CITY OF CODY
PLANNING, ZONING AND ADJUSTMENT BOARD
TUESDAY, OCTOBER 23, 2012
CITY HALL COUNCIL CHAMBERS @ 12:00 NOON

MEETING DATE:	OCTOBER 23, 2012	TYPE OF ACTION NEEDED	
AGENDA ITEM:		P&Z BOARD APPROVAL:	X
SUBJECT:	SITE PLAN REVIEW: GEE PROFESSIONAL OFFICE BUILDING (702 PLATINUM AVENUE) FILE NO. SPR 2012-41	RECOMMENDATION TO COUNCIL:	
PREPARED BY:	TODD STOWELL, CITY PLANNER	DISCUSSION ONLY:

MEETING DATE:	OCTOBER 23, 2012	TYPE OF ACTION NEEDED	
AGENDA ITEM:		P&Z BOARD APPROVAL:	X
SUBJECT:	SITE PLAN REVIEW: WYOMING AUTHENTIC PRODUCTS (MEAT PROCESSING) SPR 2012-38	RECOMMENDATION TO COUNCIL:	
PREPARED BY:	TODD STOWELL, CITY PLANNER	DISCUSSION ONLY:

LANDSCAPING PLAN

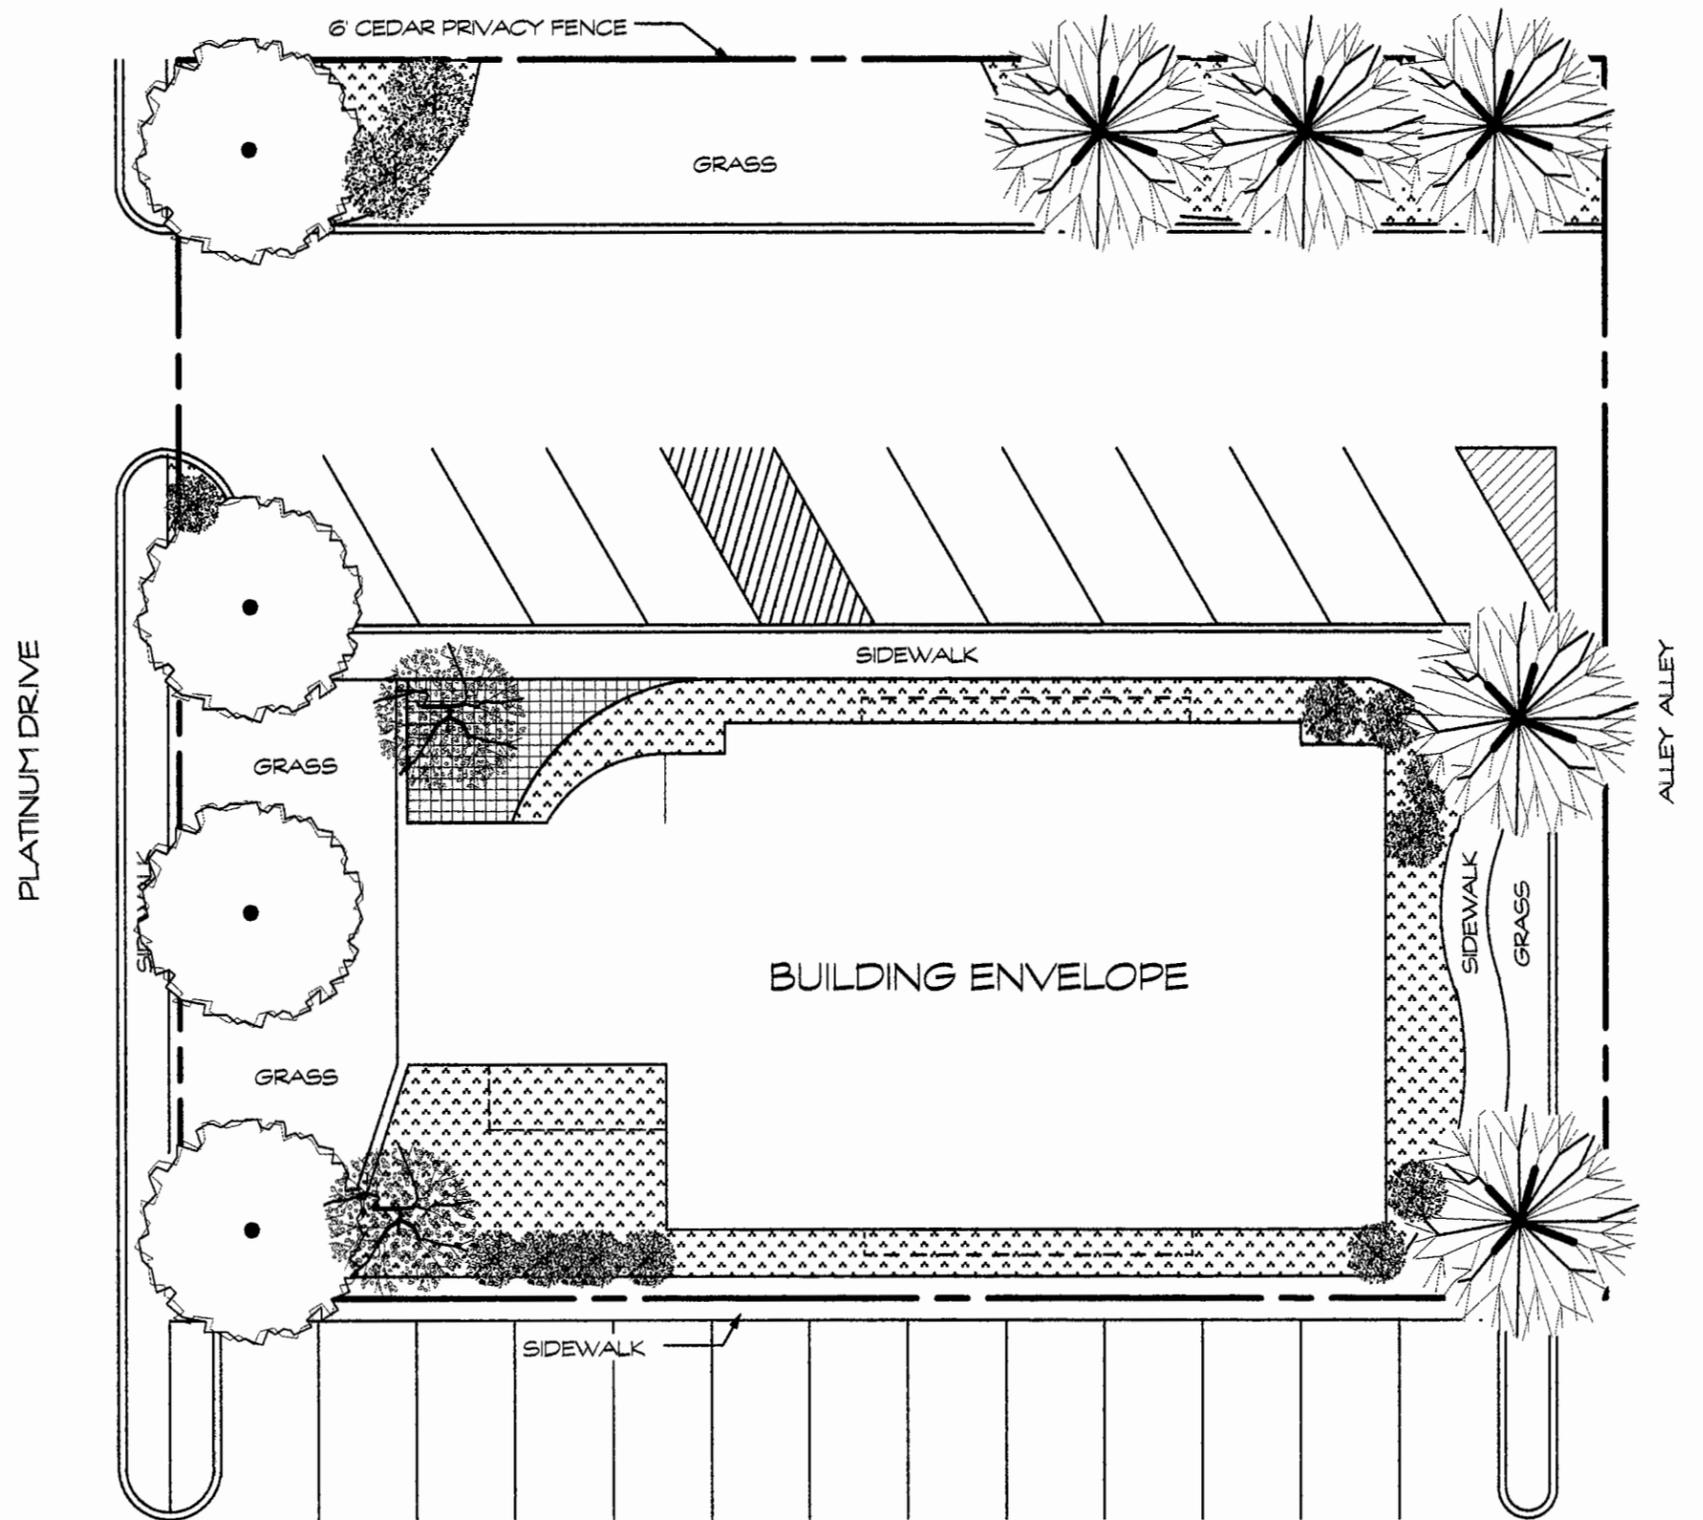
A landscaping plan is included. It includes a number of large trees, ornamental trees, shrubs, flowers, and groundcover. Due to parking spaces at the south end of the building, the two large trees in this area may need to be reduced to ornamental sized trees. So long as the tree at the northwest corner of the property is at least 10 feet from the fire hydrant, the tree locations meet applicable utility separation requirements. In staff's opinion the landscaping is of an extent that the intent of the ordinance is met.

SITE PLAN
DOCTOR GEE MEDICAL OFFICES
Platinum and 7th Streets
Park County Wyoming

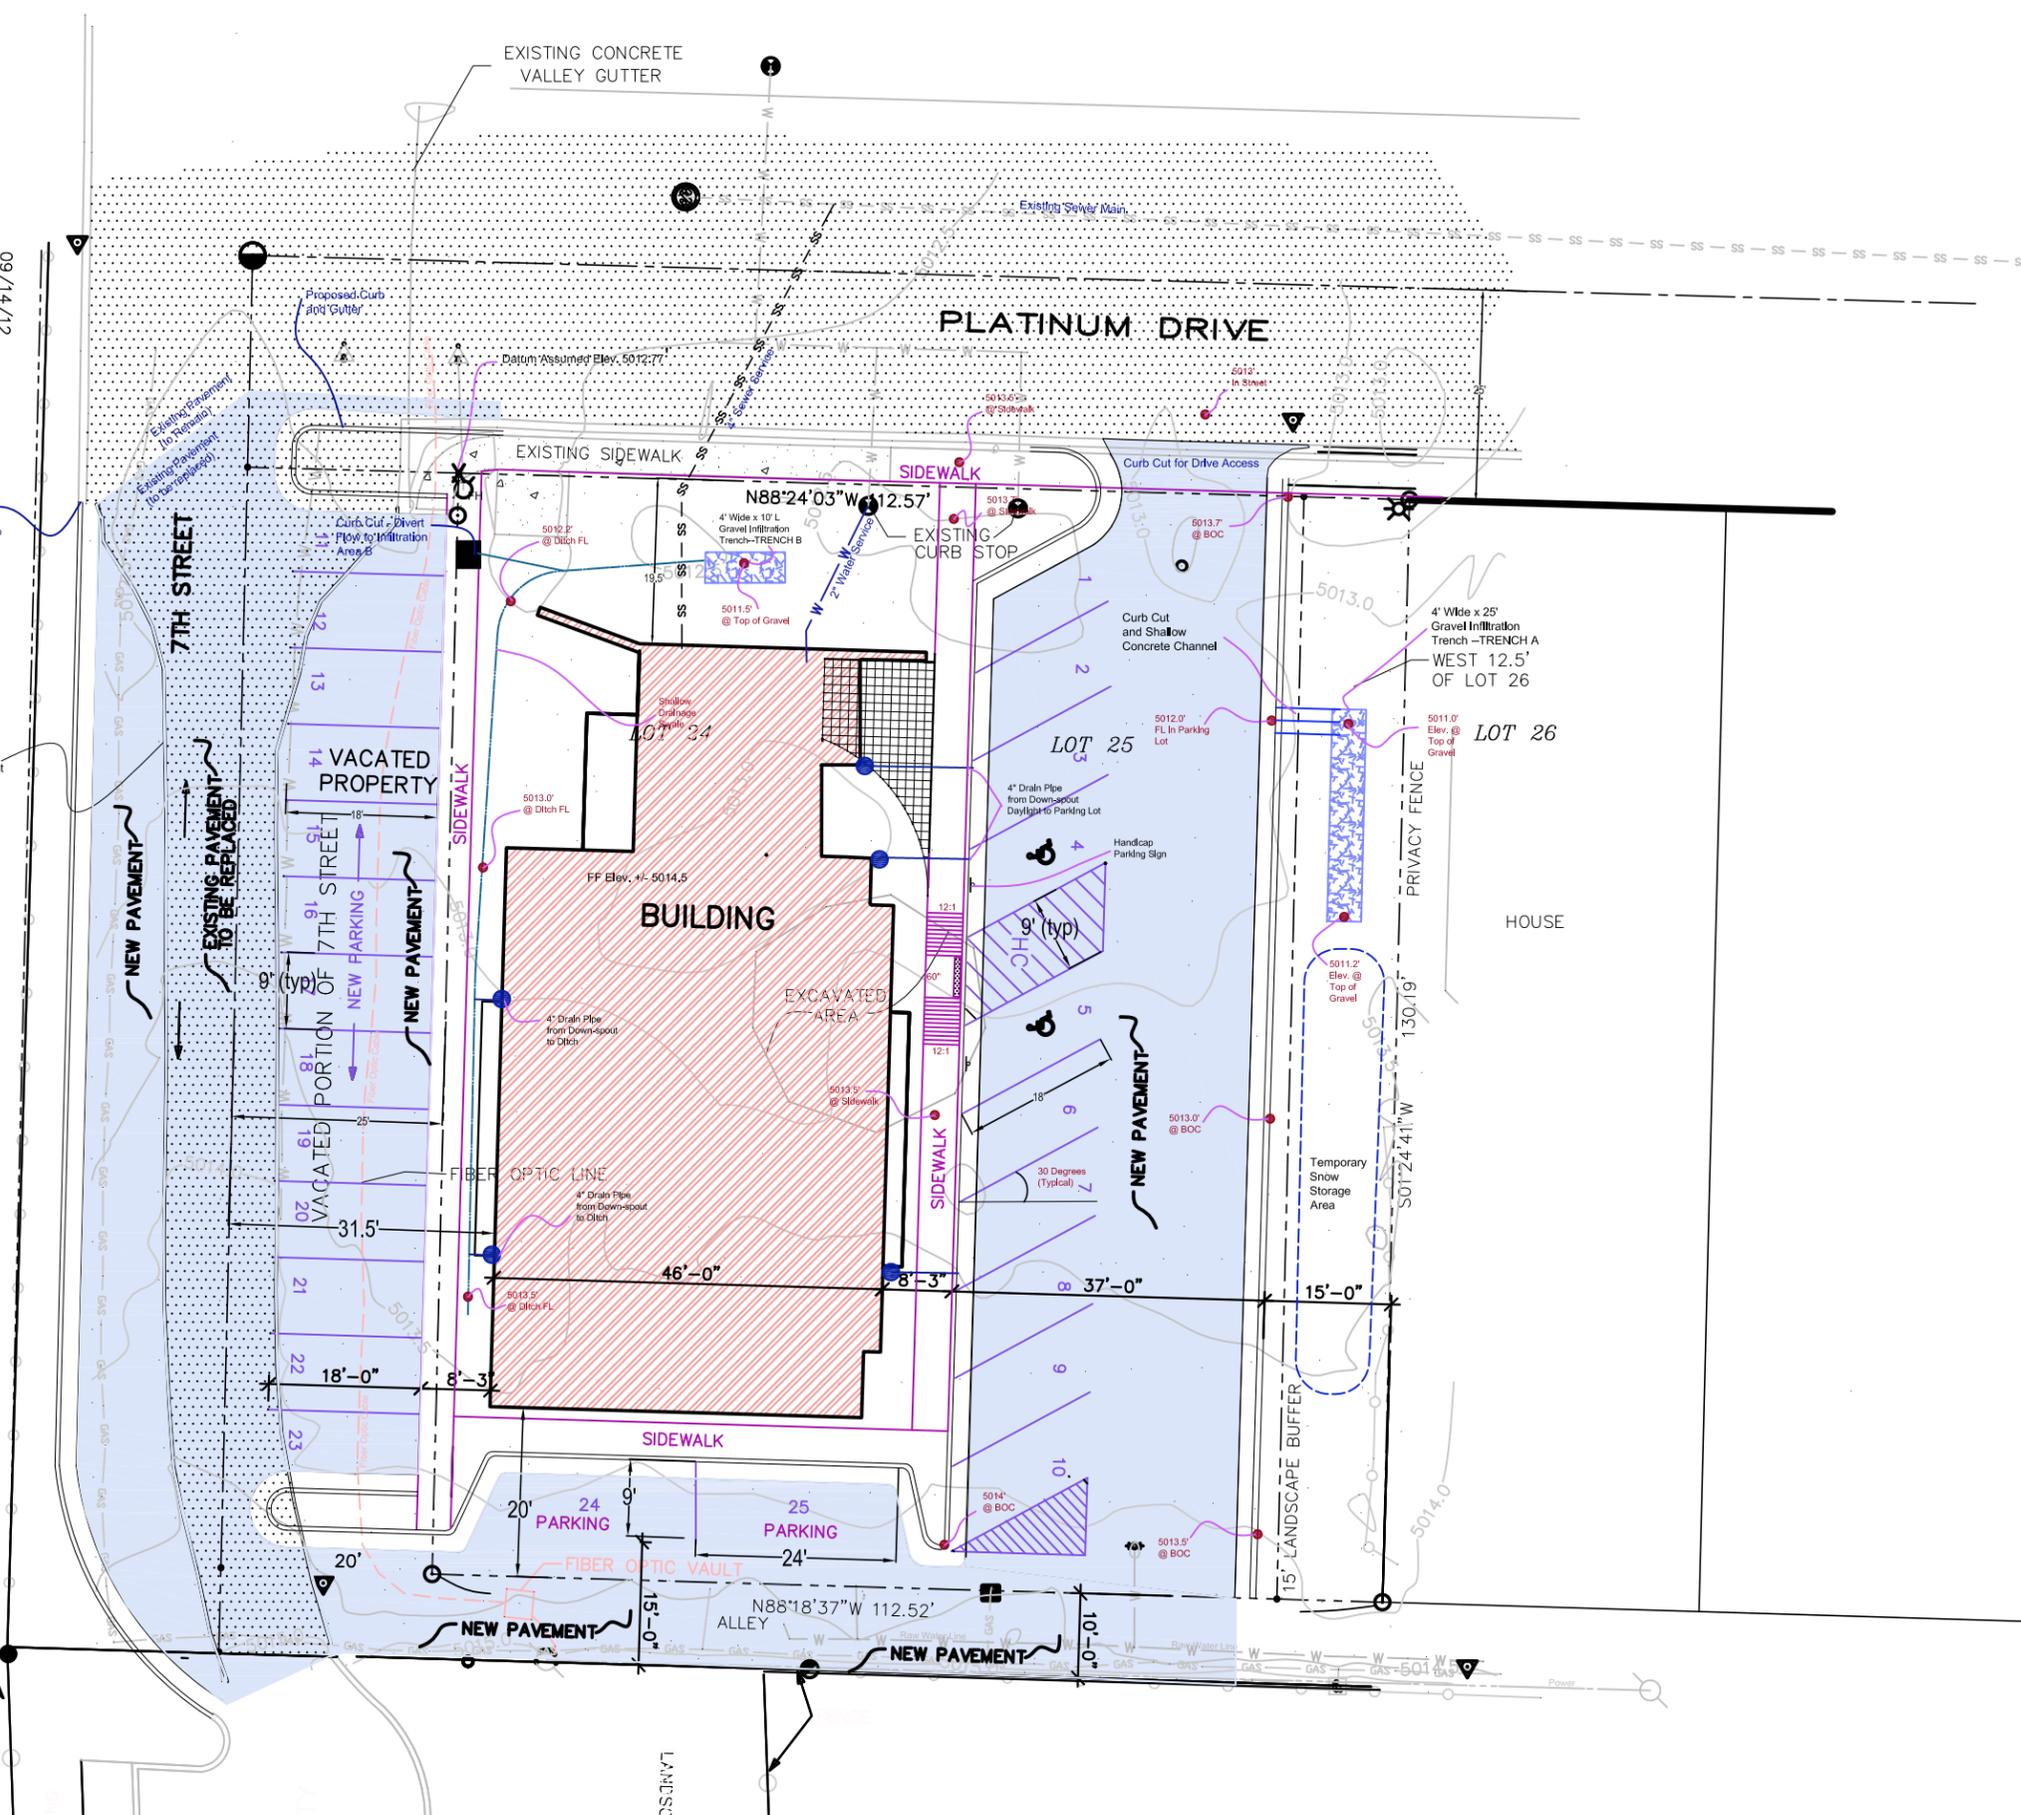
The site plan shows these improvements, with the exception of the sidewalk. Additional engineering details (cross sections, pavement depth, etc.) are needed for City Engineer review and approval before the work is conducted, although the concept depicted in the site plan clearly shows the intent.

Water service exists in the form of two ¾" water services. The latest site plan shows a proposed 2" water service. If fire protection is needed, as it would if the full basement is installed, a 4" service is typically the minimum size. A 4" line also requires a plan to be submitted to DEQ. Often the ¾" service comes off the 4" fire line, although a ¾" service already exists. Any unused water services will need to be capped at the corporation stop, which is under the street asphalt. Any new taps will need to be "hot taps". The applicant may wish to consider utilizing both existing services if it provides enough water for their needs (no fire sprinklers).

Waste disposal will be through curb-side roll-out service (no dumpster). The roll-out locations are not shown on the site plan.

9. Any additional items specified by the Board.
10. The civil site plan shall be updated to reflect the final utility connections and abandoned services, and the sidewalk grate on the west sidewalk.

AS1.1

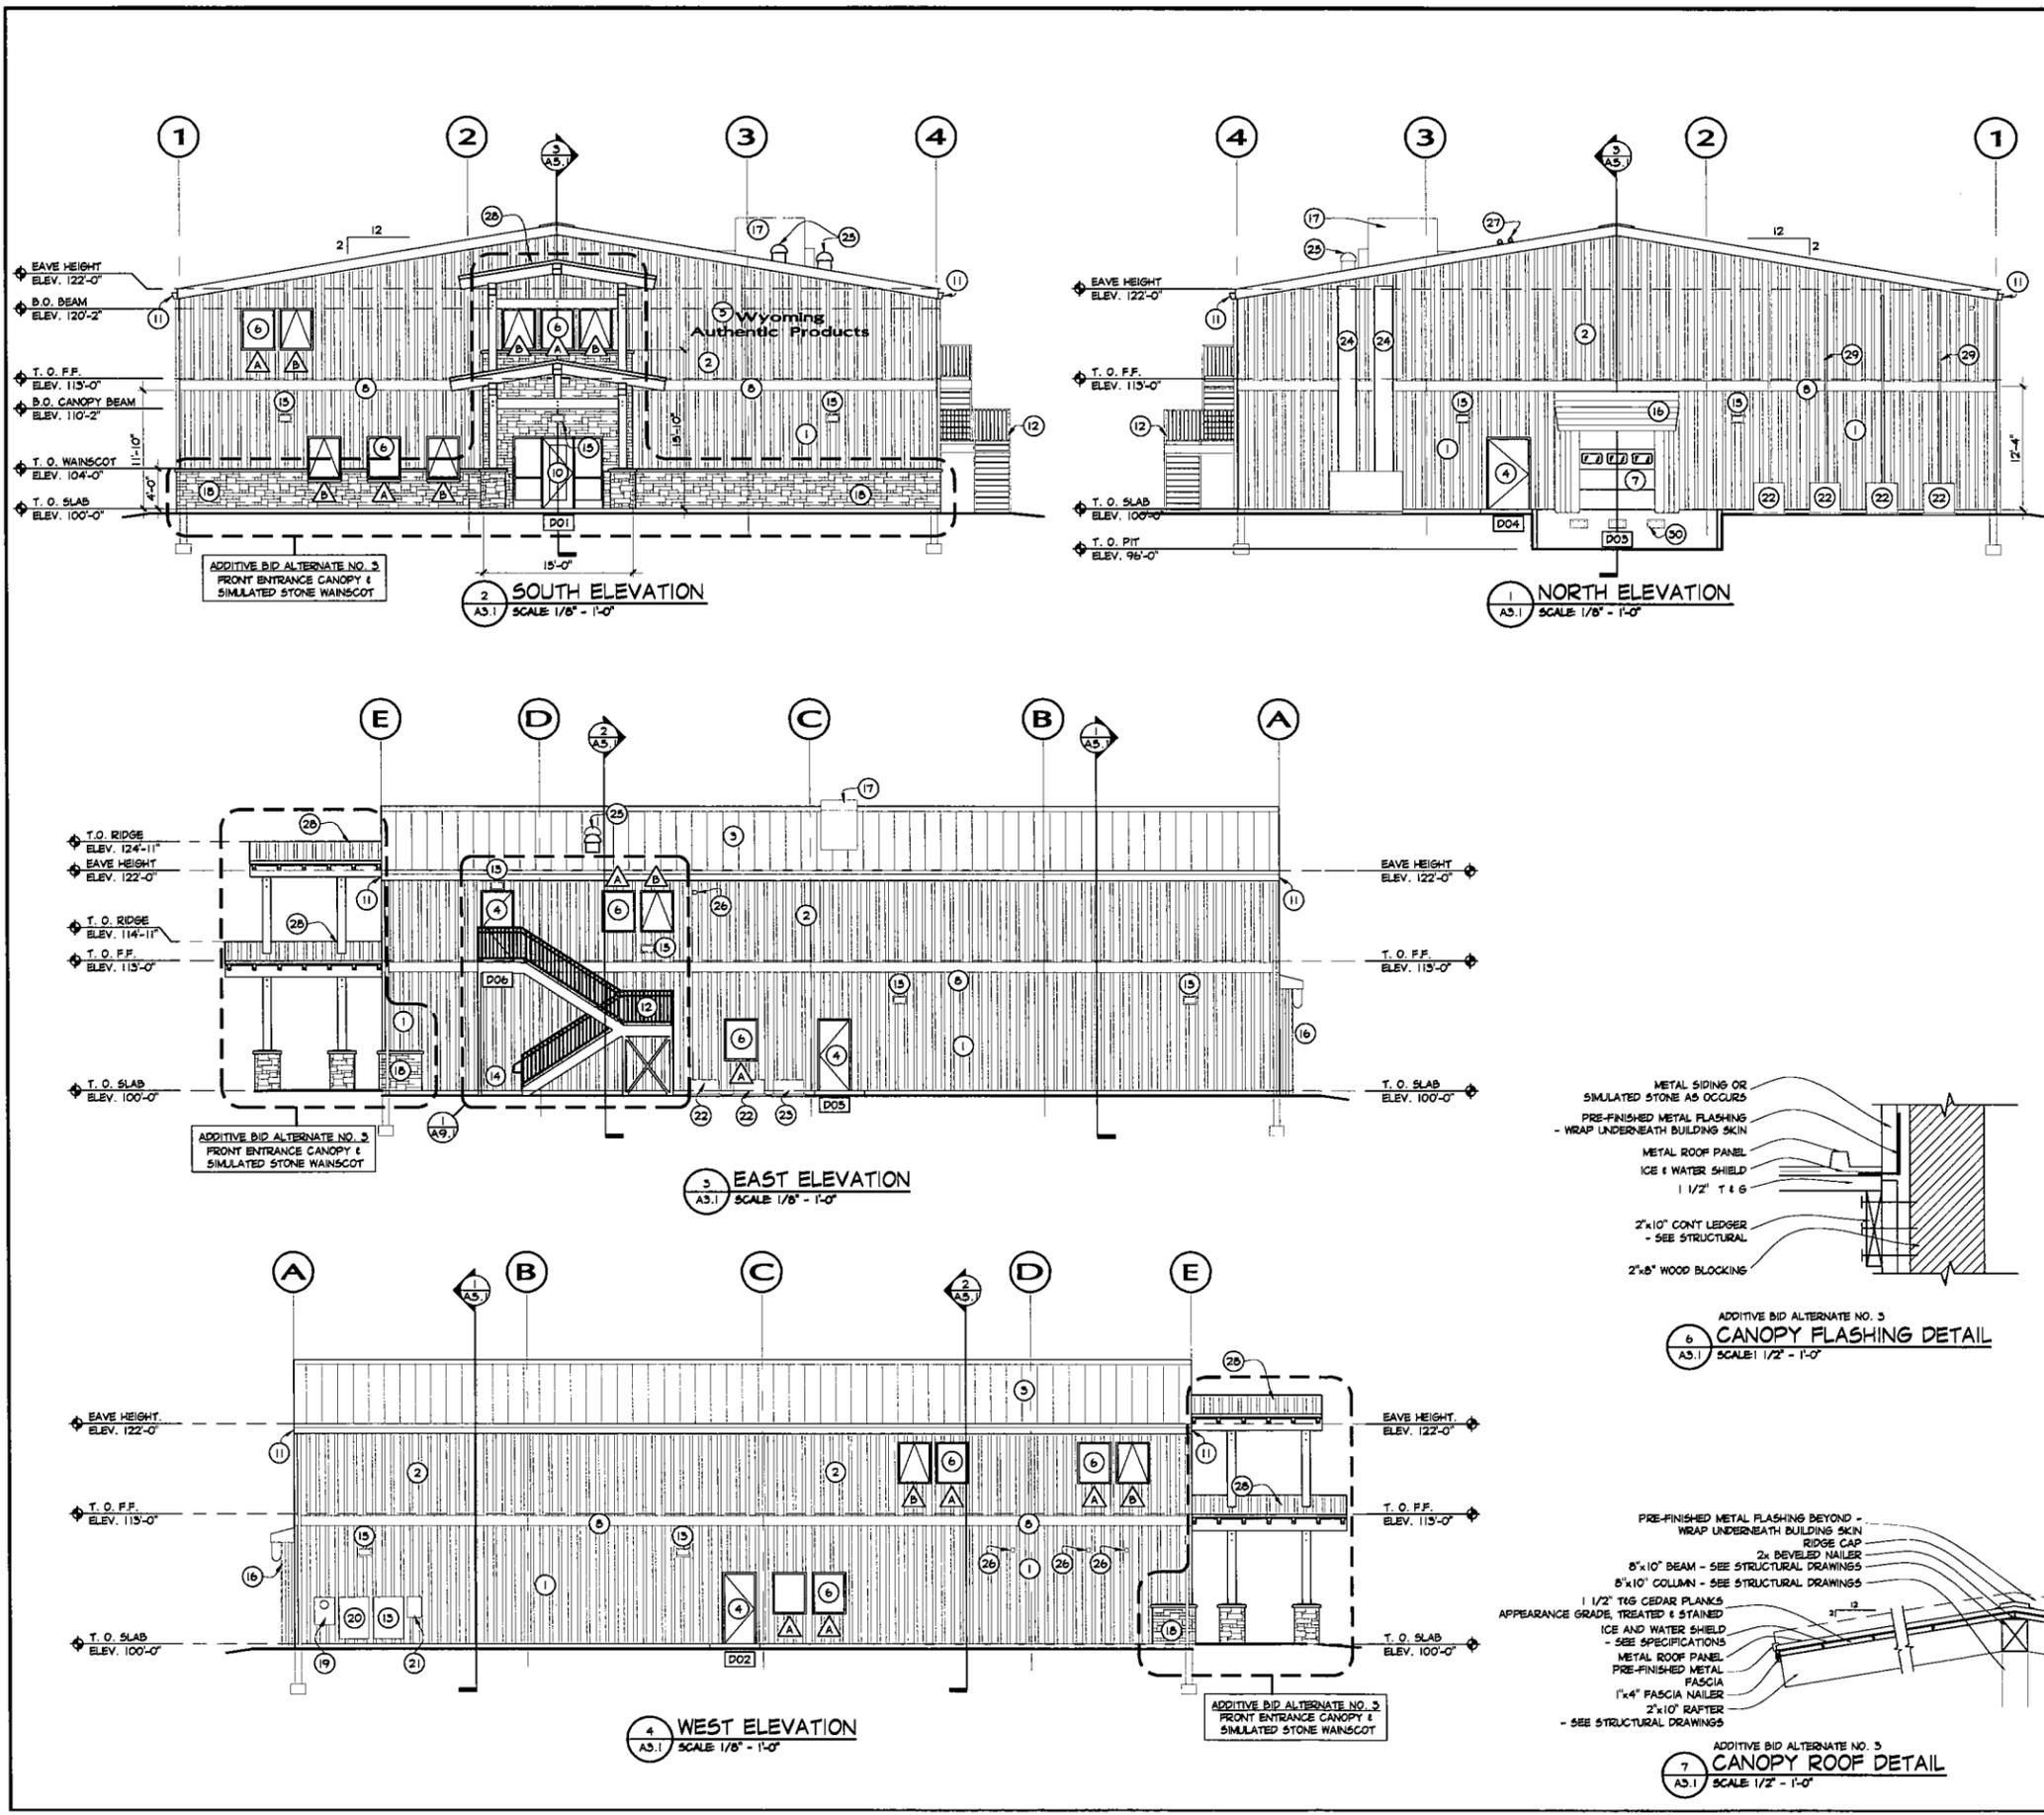
The parking ordinance requires one space per employee plus one space per average number of "business invitees" expected at any one time. The application narrative indicates a capacity of 17 employees, and 17 parking spaces are shown. Sheet AS1.1 of the site plan has a different parking calculation, which does not appear to consider capacity or growth, but only start-up needs. Between the two, it appears that seventeen spaces are needed for employees and two for visitors. The two additional spaces could be provided at the north end of the row of parking without issue.

- 2. The applicant must submit a detailed landscaping plan for the xeriscape planting area for review and approval by the Board.**

Response: Our current plans indicate a split-rail wood fence that would match the fence on the neighboring property, along with a strip of landscape rock. We currently do not have plans on landscaping the property with vegetation.

However, our current plans show a covered entrance canopy structure along with a simulated stone veneer in order to provide street appeal and be more visually interesting. This is currently a bid alternate. If the budget does not allow for the covered canopy structure once the project is publicly bid, Plan One/Architects will submit an alternate plan showing landscaping in the form of vegetation. Please see sheet A3.1 for the design of the simulated stone veneer and the covered canopy entrance additive bid alternate.
